dsPIC30F4011/4012 Family Silicon Errata and Data Sheet Clarification

The dsPIC30F4011/4012 family devices that you have received conform functionally to the current Device Data Sheet (DS70135F), except for the anomalies described in this document.

Note: This document summarizes all silicon errata issues from all revisions of silicon, previous as well as current. Only the issues indicated in the last column of Table 2 apply to the current silicon revision (A4).

FIGURE 1: dsPIC30F4011/4012 DATA EEPROM

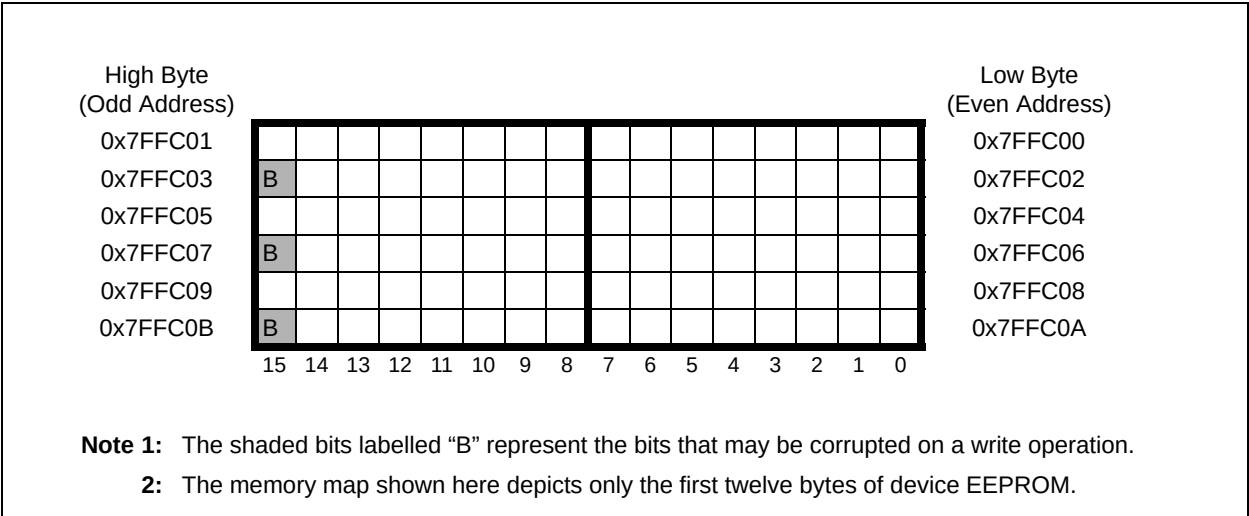
The Most Significant bit of every fourth byte in data EEPROM may be corrupted on any write operation. This write corruption may occur while using either PRO MATE®, MPLAB ICD 2 or Run-Time Self-Programming (RTSP).

Figure 1 shows the first twelve bytes in data EEPROM and indicates the affected bits.

Use program Flash memory instead of data EEPROM to store constant data.

Use less than 16 bits in each word in the available word of data EEPROM, excluding the Most Significant bit.

Avoid using every fourth byte. Example 11 shows how the ASM30 assembler can be used to allocate data in the EEPROM under this constraint.
